**CITY PLAN COMMISSION**

**FILE NUMBER:** S245-026

**REQUEST:** An application to create 4 residential lots ranging in size from 0.5281 acre (23,005 square feet) to 1.0694 acre (46,585 square feet) from a 2.9019-acre tract of land in City Block 8788 on property located on Foothill Road, northwest of Edd Road.

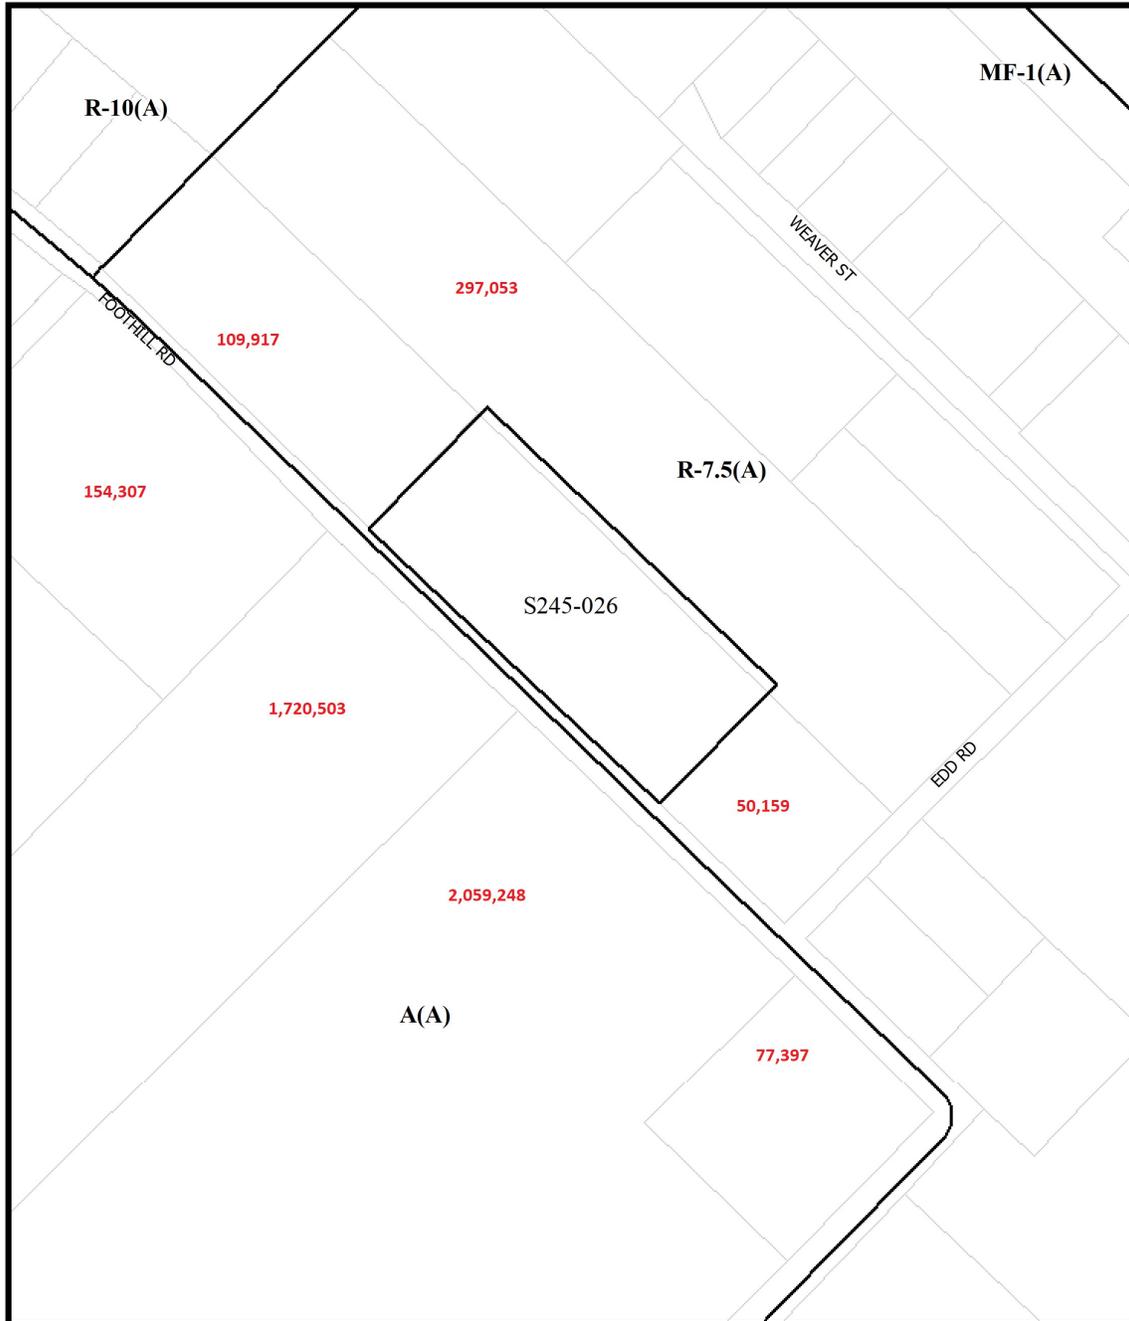
12. Submit a full set of Civil Engineering Plans (drainage, paving, street signage/marketing/lighting) prepared per City Standards by a licensed (TX) Professional Engineer to Engineering Division in Room 200, Oak Cliff Municipal Center (i.e. 311T/DP). Additions and alterations to the public infrastructure require approval and may require private development contracts with bonds. 51A-8.102 (c); 8.601(b)(4),(5),(6),(7),(8),(9)
13. Detention may be required if the capacity of available outfall is not adequate to carry the developed runoff. *Section 51A-8.611(c)*.
14. Place a note on the final plat stating "Lot-to-Lot drainage will not be allowed without proper City of Dallas Engineering Division approval" 51A 8.611(e)

15. On the final plat, dedicate 28 feet of right-of-way (via fee simple) from the established center line of Foothill Road. *Section 51A 8.602(c)*

17. On the final plat, show how all adjoining right-of-way was created. Section 51A-8.403(a)(1)(A)(xxii).
18. On the final plat, show distances/width across all adjoining rights-of-way.
19. On the final plat, show recording information on all existing easements within 150 feet of the property.
20. On the final plat, show all additions or tracts of land within 150 feet of the property with recording information. Platting Guidelines.

21. Engineer must furnish plans for water and sanitary sewer. Developer must furnish a contract for water and sanitary sewer. Sections 49-60(g)(1) and (2) and 49-62(b), (c), and (f).
22. Additional design information is required for assessment. Site plan must be submitted showing proposed development, building finished floor elevation, development, existing mains – including downstream manhole, and proposed water and wastewater service locations. Submit water/wastewater engineering plans to 320 E. Jefferson Blvd., Room 200, Attention: Water and Wastewater Engineering.
23. Wastewater main improvements is required by Private Development Contract. Submit water/wastewater engineering plans to 320 E. Jefferson Blvd., Room 200, Attention: Water and Wastewater Engineering.

24. Prior to final plat, compliance with City's Street lighting standards including illumination standards, material, installation, and activation per Street Design Manual.
25. On the final plat, change "Foothill Drive" to "Foothill Road".
26. On the final plat, identify the property as Lots 1 through 4 in City Block B/8788.
